## STRATEGIC DEVELOPMENT COMMITTEE

Report of the Corporate Director of Place

<b>Reference</b>	PA.21.02729
<b>Site</b>	42-44 Thomas Road, London, E14 7BJ
<b>Ward</b>	Mile End
<b>Proposal</b>	Erection of three sets of gates to the existing building
<b>Summary Recommendation</b>	Refuse planning permission
<b>Applicant</b>	Bellway Homes Ltd
<b>Architect/agent</b>	Savills
<b>Case Officer</b>	Katie Cooke
<b>Key dates</b>	<ul style="list-style-type: none"><li>- Application registered as valid on 23/12/2021</li><li>- Public consultation finished on 03/02/2022</li></ul>

**Figure 1:** Proposed ground floor plan

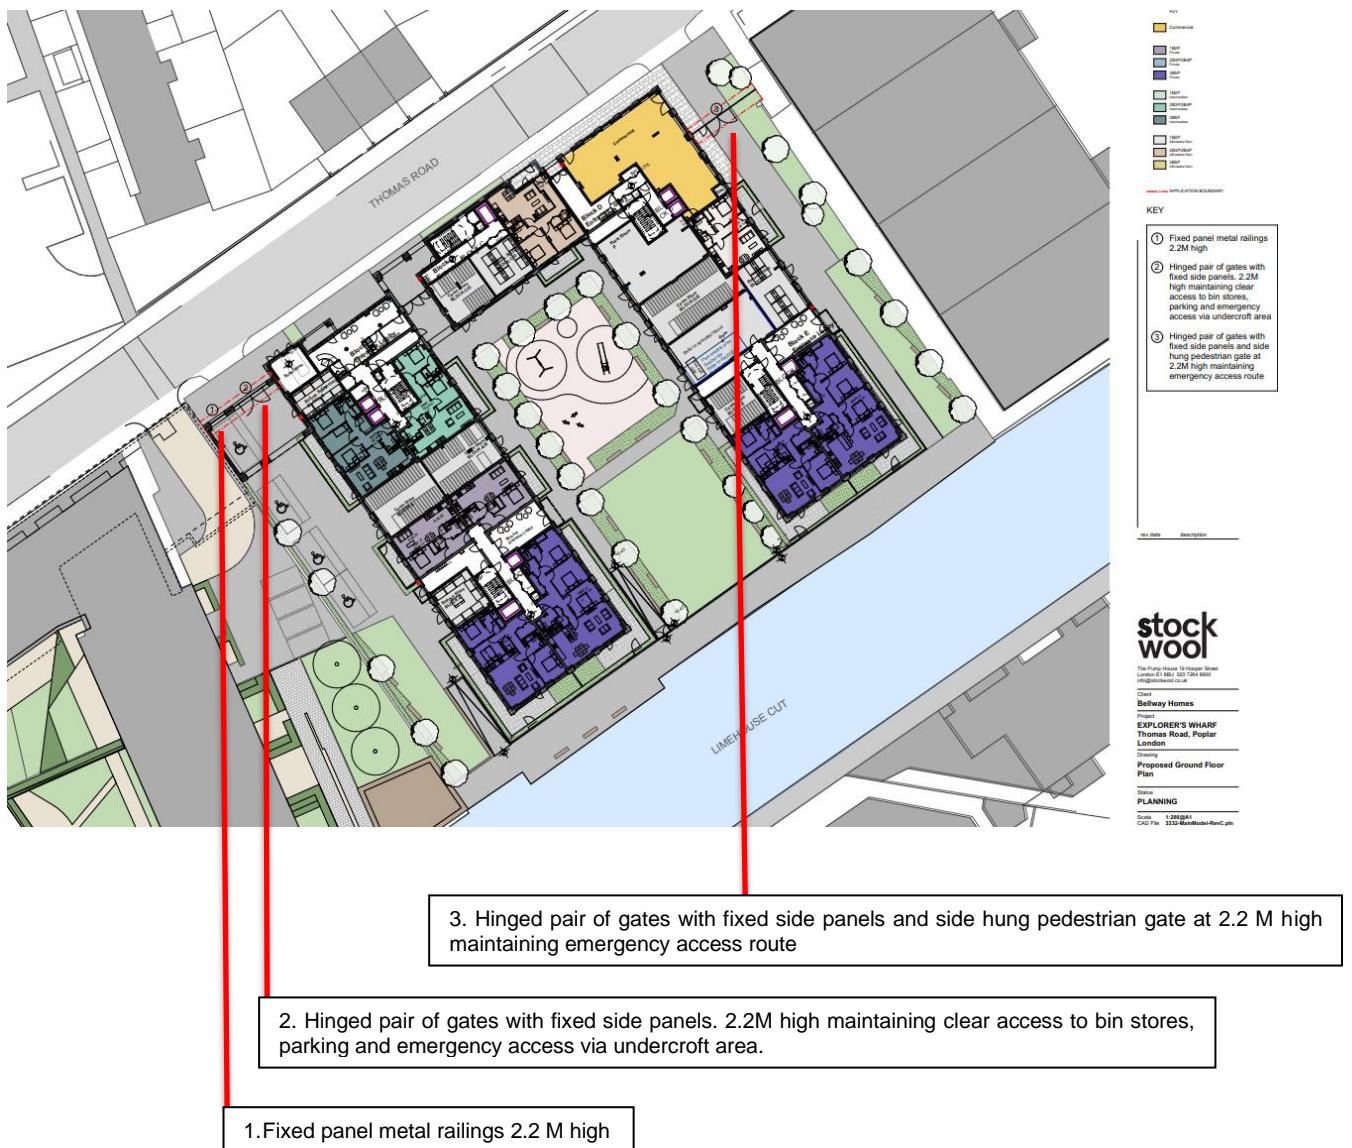
- 7.17 By locating gates at the eastern and western ends, access through the site and to the canal to the south would be restricted, thus failing to provide a positive relationship between the existing building and the Cut. Given that the canal is considered an important part of the conservation area, which provides an area of open space, restricting access would not preserve or enhance the conservation area, and fails to comply with policy S.DH3 of the Local Plan (2020).

- 7.25 The proposed pedestrian gates at the boundary of 42-44 Thomas Road would act to restrict movement of the public along this path, by stopping people travelling from the site onto the towpath. This is contrary to Policy D.DH2, which seeks to ensure that new development protects and promotes a well-connected street network and Policy SI 16 of the London Plan, which explicitly sets out that the Thames path and towpaths, such as the Limehouse Cut pathway, should be ‘public and not private spaces’.

**Figure 2 – Proposed visuals and materials of the gates**

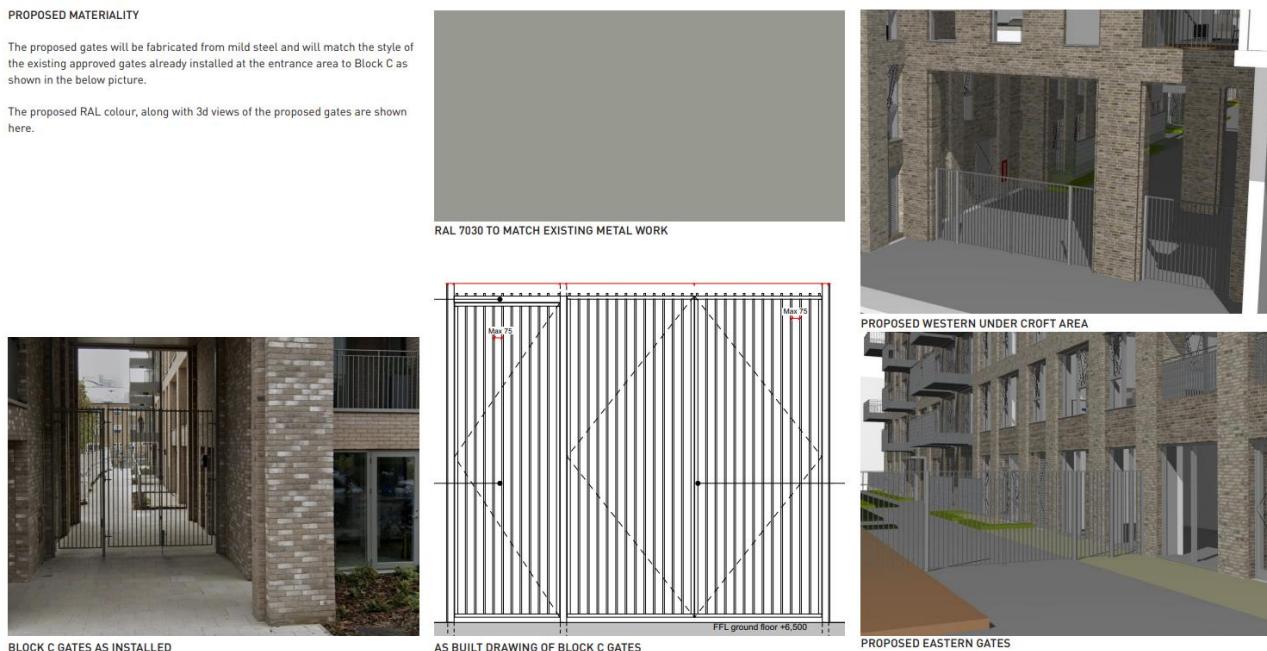
7.9 The proposed gates are simple in design and would be sympathetic to the surroundings. It is not considered that these would detract from the character and setting of the wider conservation area.

- 7.12 The design and the materials of the proposed gate will match that of the existing gates to Block C, therefore there are no objections to the appearance of these gates.

**Figure 3:** (Left to right) Eastern end of canal path blocked and western end of canal path blocked

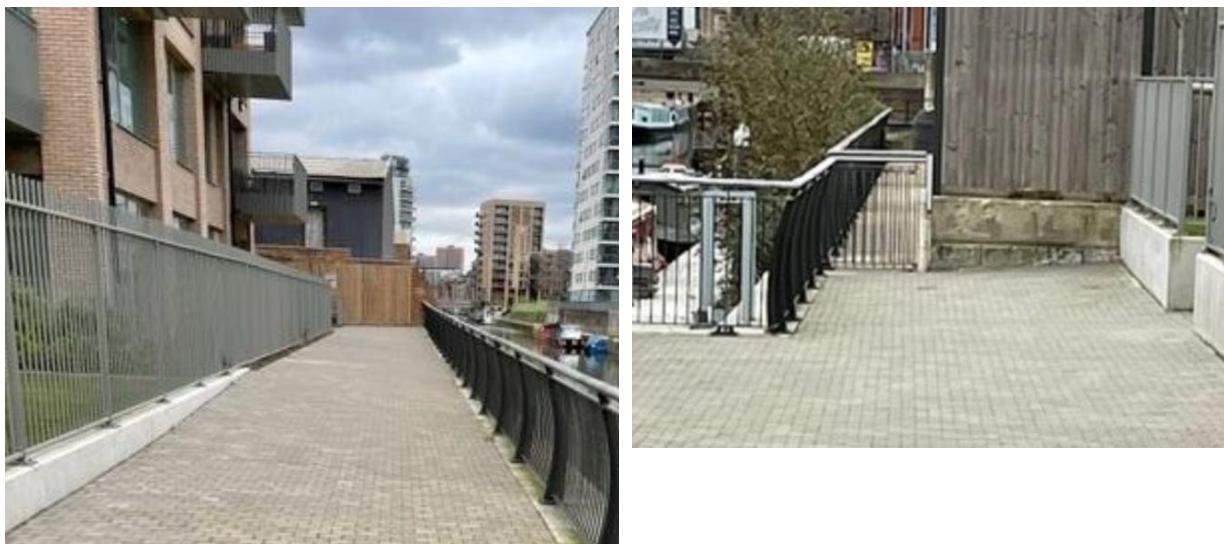
- 7.28 The photos in Figure 3 below show that the eastern and western boundaries along the canal have been blocked up and there is no public access.
- 7.29 The canal and its secured towpath should be open and unrestricted to allow the future development of the canal footpath to be connected. Furthermore, the current public access arrangement around the site allows people access to the canal side and this would be privatised if public access is restricted.

**Figure 6:** Schedule 8 of the signed S106 which shows the areas of 'Public Open Space' (excluding the courtyard, private amenity, defensible space)

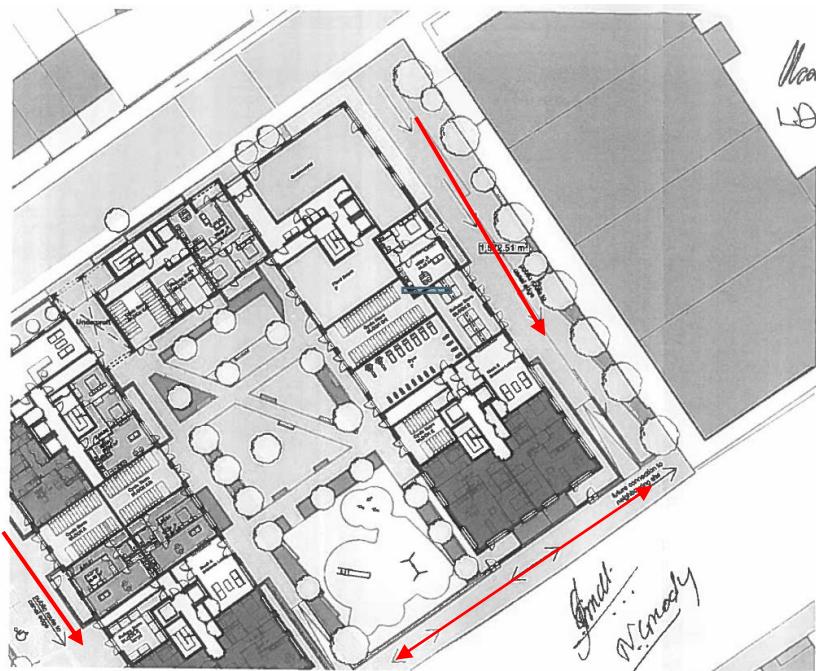
- 7.35 Figure 6 is an extract taken from the final signed legal agreement to PA.16.1041 and shows the publicly accessible routes through the site to the canal edge and also clearly indicates the future connection to neighbouring sites along the canal path (marked on the plan in red to assist the reader).
- 7.36 Clause 1d of Schedule 8 of the legal agreement states that 'the Owner covenants with the Council to retain the Public Open Space for use as a publicly accessible open space for the lifetime of the development.'
- 7.37 In summary, should the 3 gates be approved, the publicly accessible routes which were approved as part of the planning permission would no longer be available and obligations in the legal agreement cannot be met.
